REGIONAL REVIEW FINDING

Submitting Local Government: Fulton County
Name of Proposal: Corporate Campus

Preliminary Report:	Feb 24, 2005	DEVELOPMENT OF REGIONAL IMPACT REVIEW REPORT	Project:	Corporate Campus #740
Final Report Due:	March 25, 2005		Comments Due By:	March 10, 2005

V/C Ratios

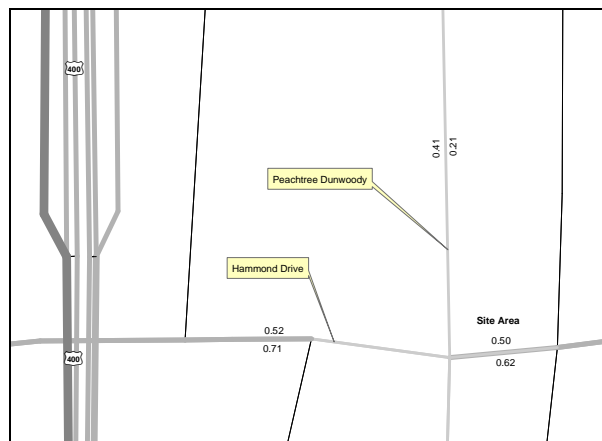
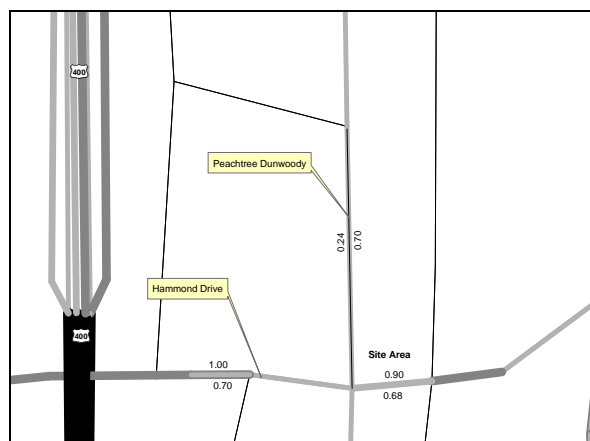
For the V/C ratio graphic, the data is based on 2005, 2010 and 2030 A.M./P.M. peak volume data generated from ARC's travel demand model for Mobility 2030, the 2030 RTP and the FY 2005-2010 TIP, adopted in December 2004. The travel demand model incorporates lane addition improvements and updates to the network as appropriate. As the life of the RTP progresses, volume and/or V/C ratio data may appear inconsistent due to (1) effect of implementation of nearby new or expanded facilities or (2) impact of socio-economic data on facility types.
